03/06/2020
CAL FTL 32-003

**Subject: Airliner 21K Lightweight Extra Duty
Rear Suspension Height Control Valve Installation**

Models Affected: Fifteen Freightliner M2 vehicles (Model Year 2021) equipped with a single rear suspension leveling valve manufactured in Santiago between January 22, 2020 and February 13, 2020

The rear suspension height control valve and linkage installation on these 15 vehicles will need to be corrected using the following work instructions.

Fig. 1, Height Control Valve Mounted on Rear of Mounting Bracket

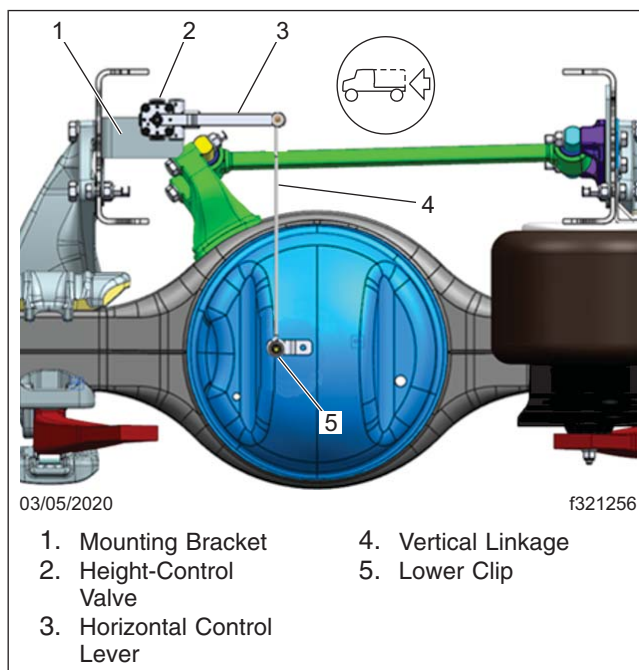
1. Park the vehicle on a level surface using a light application of the brakes, shut down the engine, set the parking brake and chock the rear tires.
2. Release the parking brake.
3. Drain all the air from the air tanks.
4. Locate the Airliner rear suspension height-control valve located on the inside of the left-hand frame rail just rear of the drive axle.
5. Remove any zip ties from the air lines or the valve that may restrict removal of the height-control valve from the valve mounting bracket.
6. Remove the nut and washer that attaches the existing height-control valve lever arm linkage to the lower clip on the axle housing. See [Fig. 1](#).

Fig. 2, Holding the Mounting Studs in Place With an Allen Wrench

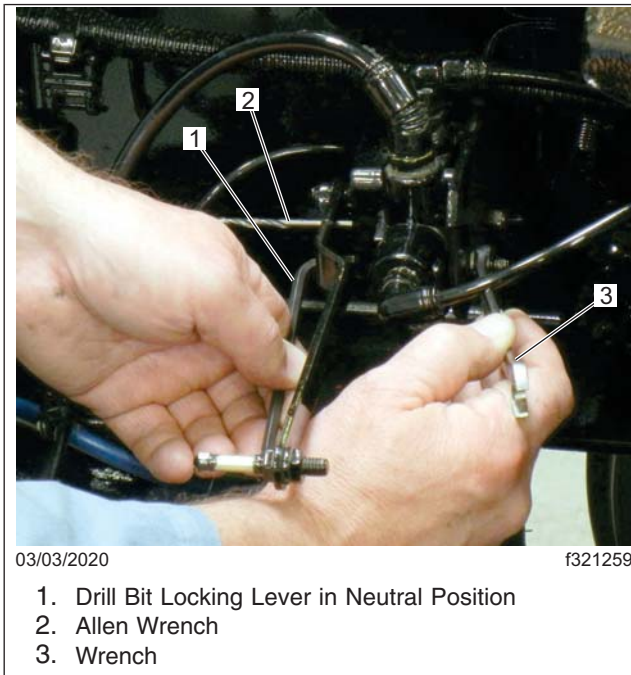
- 7.1 While holding the height control valve mounting studs in place with an Allen wrench, remove the nuts and washers that attach the valve to the mounting bracket. See [Fig. 2](#).

Fig. 3, Height Control Valve on the Forward Side of the Mounting Bracket

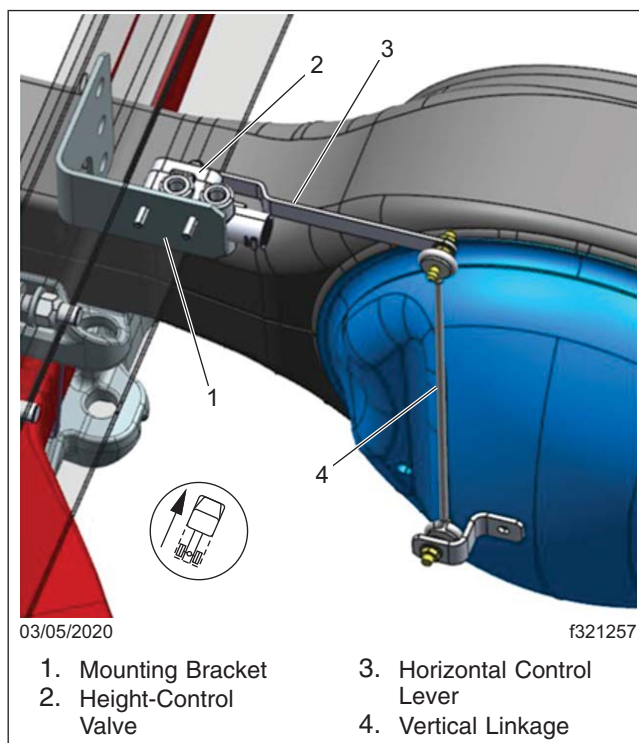
- 7.2 Remove the height control valve from the bracket and discard the linkage.
8. Relocate the height control valve to the forward side of the mounting bracket (see [Fig. 3](#)) :

- 8.1 While holding the height control valve mounting studs in place with an Allen wrench, install the nuts and washers. Tighten the nuts 95 lbf-in (1100 N-cm). Do not over-tighten.
9. Install the new linkage (part number 16-14494-002). See [Fig. 3](#).
10. Connect the linkage to the valve lever and lower clip on the axle housing. See [Fig. 1](#) and [Fig. 3](#).
11. Start the engine and build the system air pressure to at least 100 Psi (690 kpa). Shut down the engine.
12. Measure the suspension ride height at the left-hand side clamp group. See [Fig. 4](#).
 - 12.1 If the suspension ride height measures 111mm +/- 6mm (4.37" +/- 0.25"), the suspension ride height is within the specification.
 - 12.2 If the suspension ride height is not within this range, follow the Ride Height Adjustment procedure.
